# P802.1DD

## Comment 27 – Discussion

# Startup

# Comment 27

### **1 6.3.10.1 Startup**

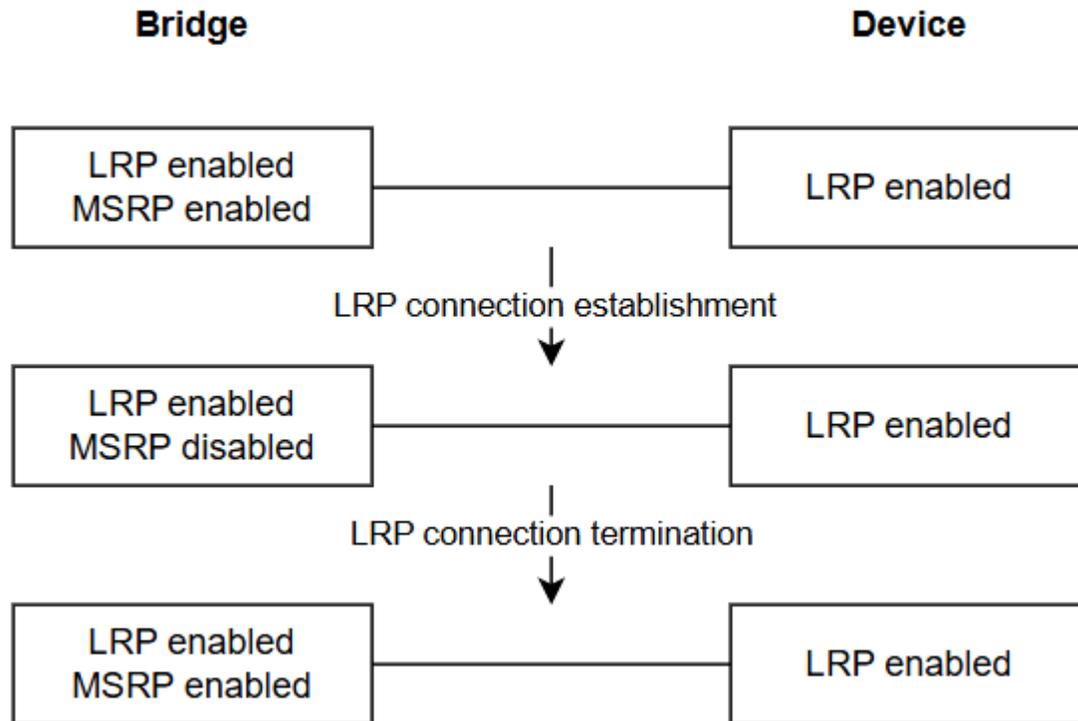
Explanation could be expanded to explicitly cover the case of receiving a MSRPDU and thus disabling LRP?

# What even could cause a problem?

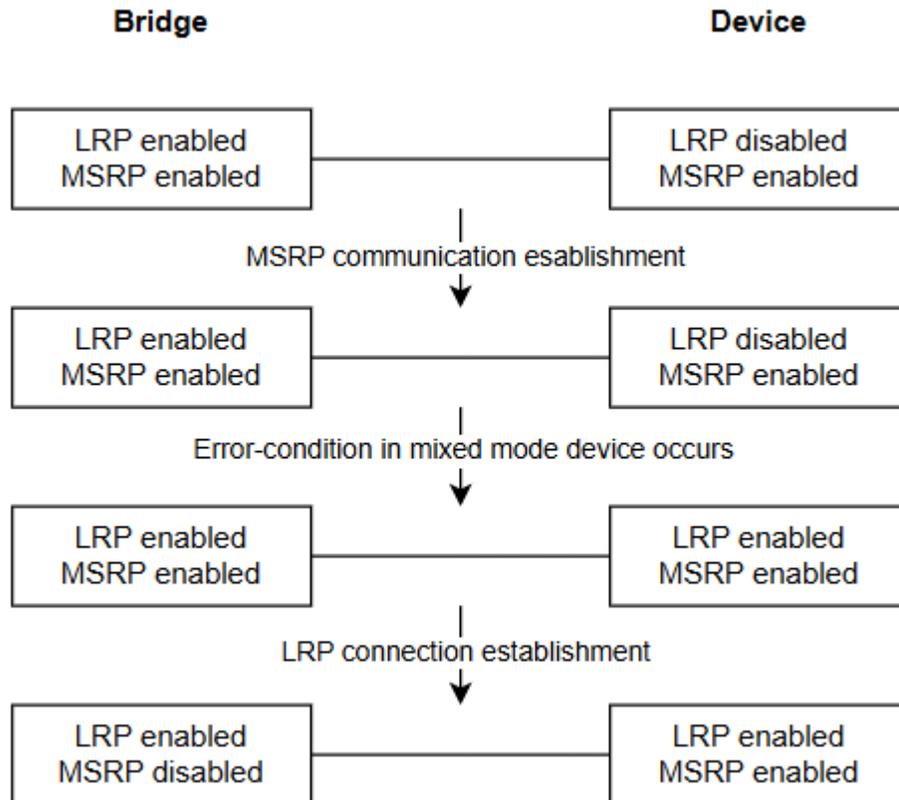
- Only erroneous mixed mode devices that start LRP communication while already doing MSRP communication can cause issues

# Possible prevention of this problem

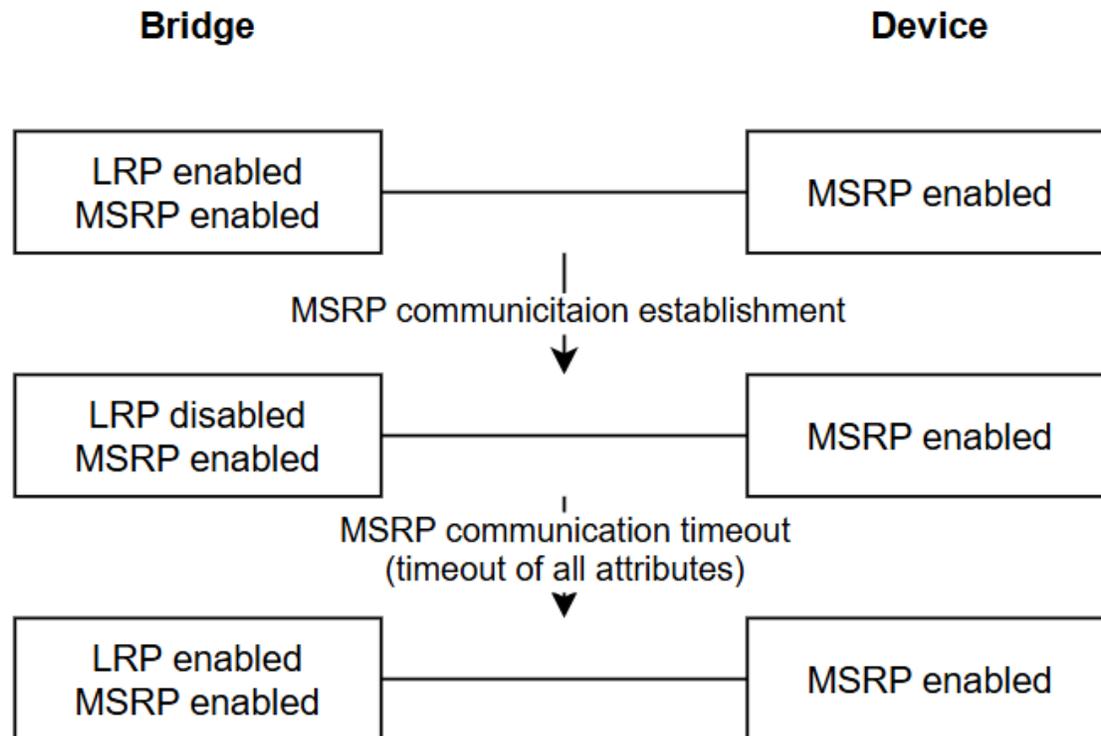
- Disabling LRP for this port in the bridge in case that MSRP communication is started could prevent this issue
- But there is no easy possibility to detect if the MSRP communication is no longer needed
  - -> timeout of all MSRP attributes could be one solution

- Is it necessary to add the complexity of timeout-detection of MSRP attributes?
- Or would it be sufficient to add a note to the draft:

“Establishing an LRP connection to a bridge that currently uses MSRP on this port leads to termination of all MSRP attributes on this port”
